ARBORICULTURAL REPORT

Summary Report for Cumberland Council

Reference: 4/24/2104/001

Location: RHEDA CROSS, RHEDA PARK, FRIZINGTON

Screenshot from the Westwood Landscape Tree Mitigation Plan - WW/L01 Rev.C (dated 24/03/25)

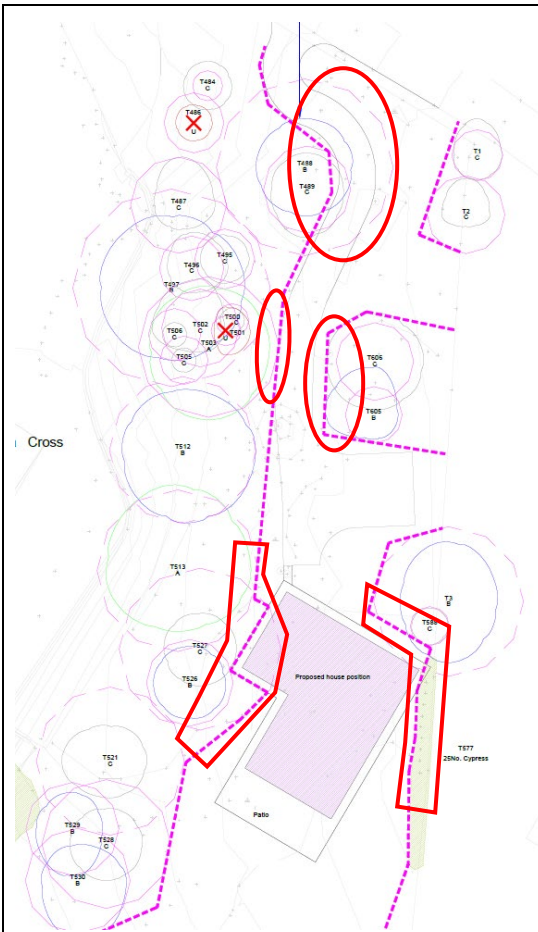
The Tree Mitigation Plan shows several areas where the proposed layout or construction operations are likely to impact on the trees and/or their root protection areas (RPAs). We have outlined these areas in red.

Construction Zone

The plan shows a line of the protective fencing (magenta dashed line) which appears to have been drawn arbitrarily to avoid the trees, their RPAs and the proposed scheme layout. The proposed protective fencing line does not appear to allow for construction traffic movements around the outside of the building or scaffolding around the building to allow construction. The protective fencing locations need to be practical, otherwise it is likely to result in loss of retained trees.

We suggest using a minimum of a 2m offset from the building footprint for scaffolding. In addition, in order to access the southern part of the proposed building, machinery is likely to require a further 3m offset for machinery and materials access. Along the driveway, we suggest a 1m offset either side to provide sufficient space to adequately construct the driveway.

Given the provided information, we consider the proposed development layout is likely to cause significant harm to the retained trees protected by a Tree Preservation Order. In order to make further assessment, we will require further details about a practical construction zone around the building and driveway, installation of suitable ground protection for the construction of the driveway within the calculated RPAs, and special foundation techniques for construction of the proposed building within the calculated RPAs. These details should follow the guidance and recommendations in the British Standard (BS 5837:2012).
